1. PLUS Radios: FGR2-P and FGR2-PE

These sections describe the updates and known limitations in each software version. The most recent version is listed first.

Figure 1: Security window - Reboot Interval list box

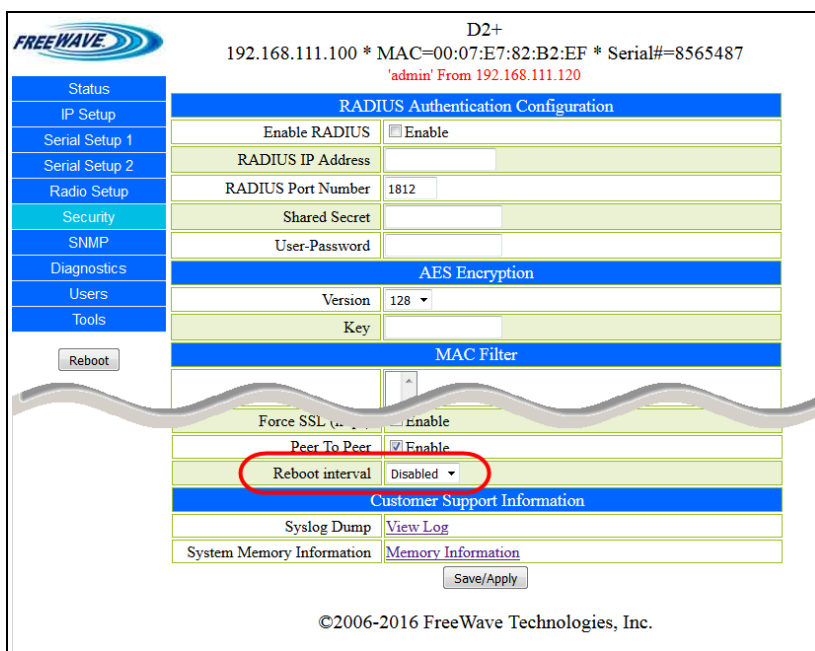
In the **Security** window, in the **Miscellaneous** area, a new **Reboot Interval** list box option has been added.

- By default, the **Reboot Interval** is **Disabled**.
 - If **Disabled** is selected, the PLUS Radio will operate without automatically rebooting.
 - When an interval (e.g., **1 Hour**, **1 Day**, **30 Days**) is selected, the scheduler automatically reboots the PLUS Radio when the reboot interval expires.
